| Model: MD-A1b(P3000) | Date: 06-Mar-12 | No.: RE0A0001g |

| Subject: Firmware Release Note: MD-A1b | | Prepared by: S. Ishizu | |

This RTB has been issued to announce the firmware release information for the **MD-A1b**

| Subject: Cursor Indicator Disappear when initial set-up | | Prepared by: Shingo Ishizu | |

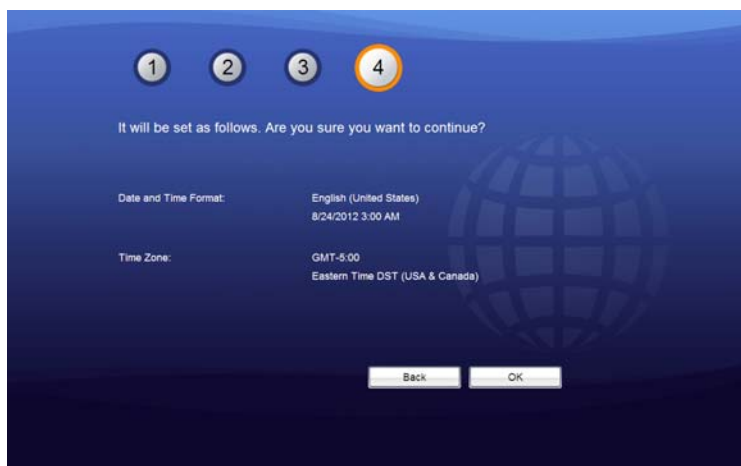
The cursor disappears when the “up” arrow (▲) is pressed during the initial set-up.

Normal:

After the (▲) key is pressed:

Turn the machine OFF/ON, and then do the initial set-up again.

The firmware will be modified and then released in March 2012.
